DMC:	342-49-037 – SERVICE BULLETIN
Title:	Application of grease required on the two fuel manifolds
Issue number:	001
Issue Date:	28-01-2021

This Service Bulletin (SB) is applicable to all APU power plant fitted on Leonardo Helicopters AW189 / AW149 helicopters.

Following a few occurrence of APU fuel line leakage, SAFRAN POWER UNITS decides to add lubrication to the rear part of each fuel line ferrule to reduce the torsion when the nuts are tightened.

Figure 1 : Burner manifold - Remove procedure

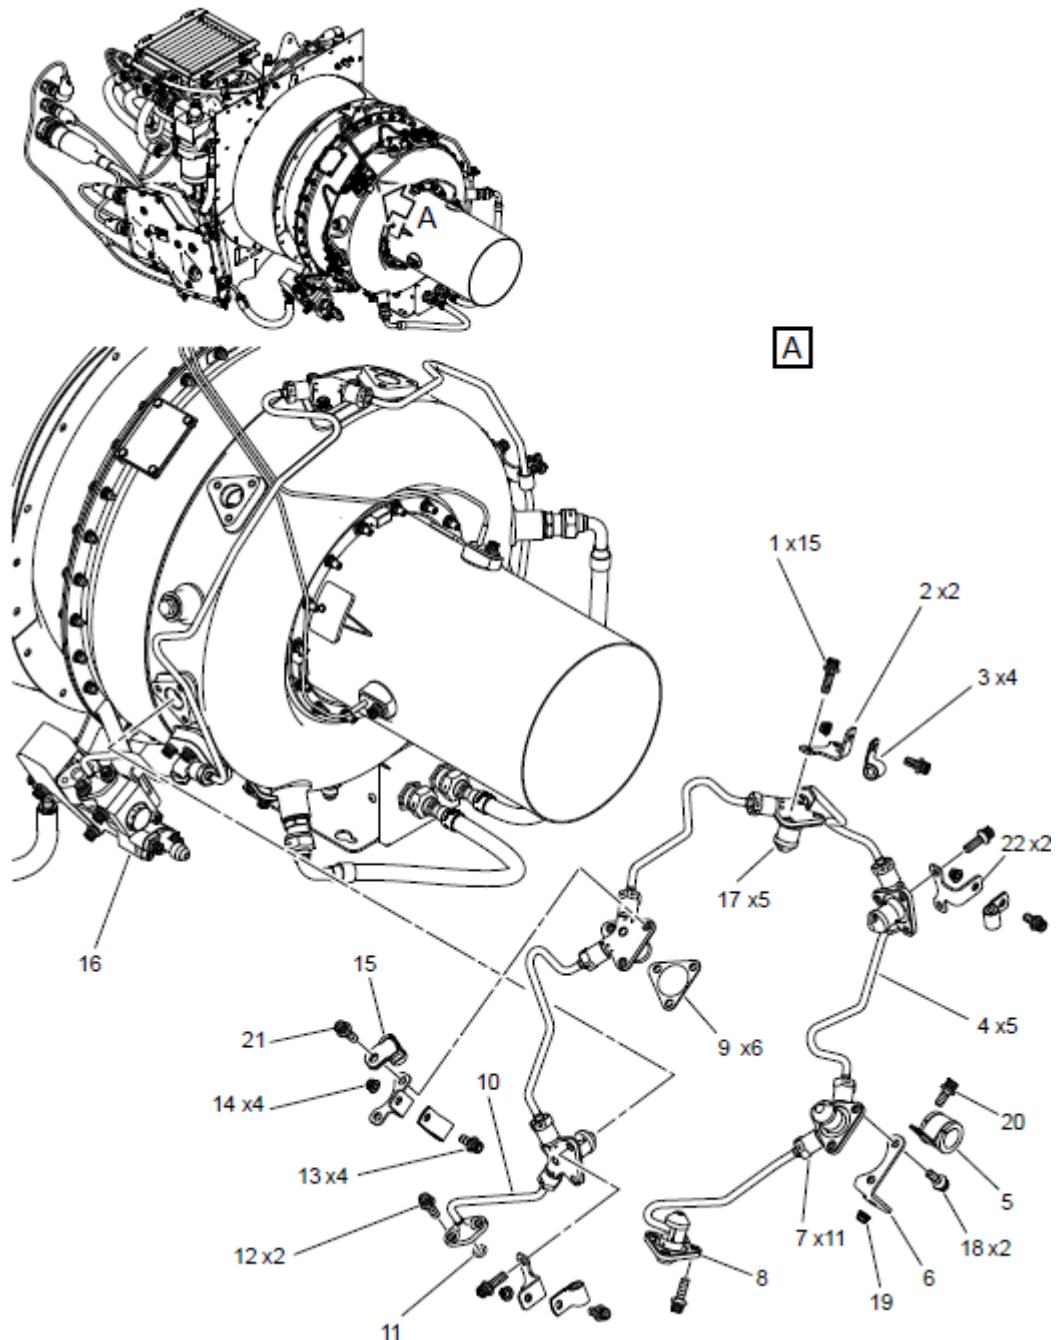
- Do not lubricate the threads of the nuts (7).
- Apply a small amount of grease AIR 3565/A to the location shown in the Figure 2.

Lubricate the rear part of the 11 burner manifold ferrules with grease AIR 3565/A.

This step must be performed in the DM 89-A-49-31-05-00A-720A-B (between steps 8 and 9) and will be integrated in the next issue of the technical publication.

3. Tighten by hand the 11 nuts (7, Figure 1) of the five fuel lines (4, 10).
4. Torque the eight screws (1) to 5 Nm (44.254 lbf.in) with a standard torque wrench or a special torque wrench (M25740).

5. Torque the 11 nuts (7) to 11 Nm - 12 Nm (97.360 lbf.in - 106.210 lbf.in) with a standard torque wrench or a special torque wrench (M26470).
6. Torque the 7 screws (1), the screw (21) and the 2 screws (18) to 5 Nm (44.254 lbf.in) with a standard torque wrench or a special torque wrench (M25740).

Figure 3 : Ignition manifold - Remove procedure

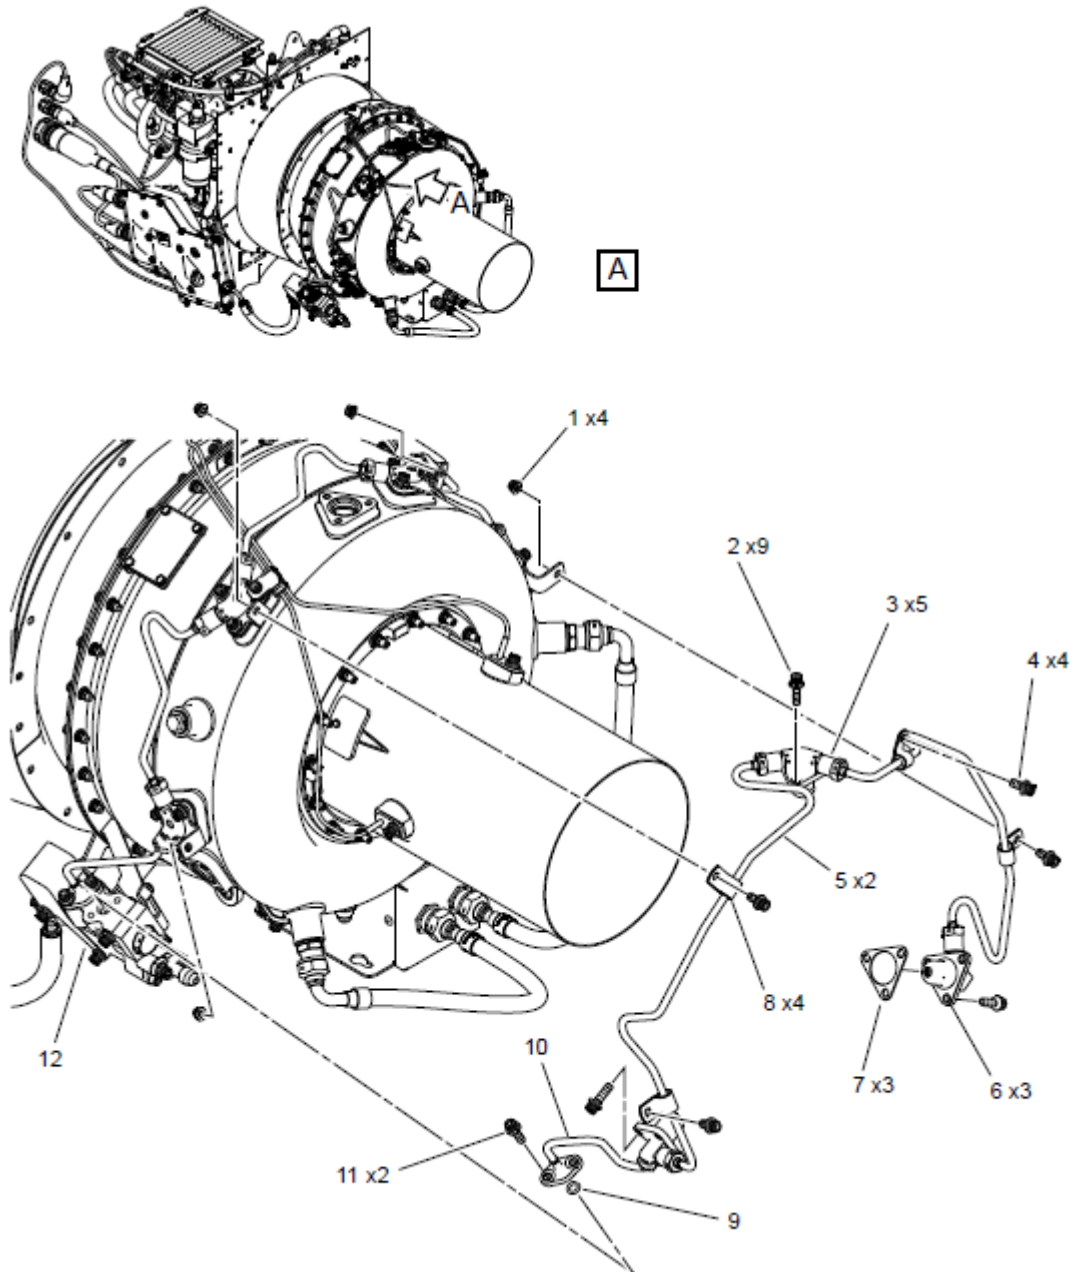
- **Do not lubricate the threads of the nuts (3).**
- **Apply a small amount of grease AIR 3565/A to the location shown in the Figure 2.**

Lubricate the rear part of the five ignition manifold ferrules with grease AIR 3565/A.

This step must be performed in the DM 89-A-49-31-09-00A-720A-B (between steps 6 and 7) and will be integrated in the next issue of the technical publication.

3. Tighten by hand the five nuts (3) of the five fuel lines (5, 10).
4. Torque the nine screws (2) to 5 Nm (44.254 lbf.in) with a standard torque wrench or a special torque wrench (M25740).
5. Torque the five nuts (3) to 11 Nm - 12 Nm (97.360 lbf.in - 106.210 lbf.in) with a standard torque wrench or a special torque wrench (M26470).
6. Lock the five nuts (3) with Lockwire.
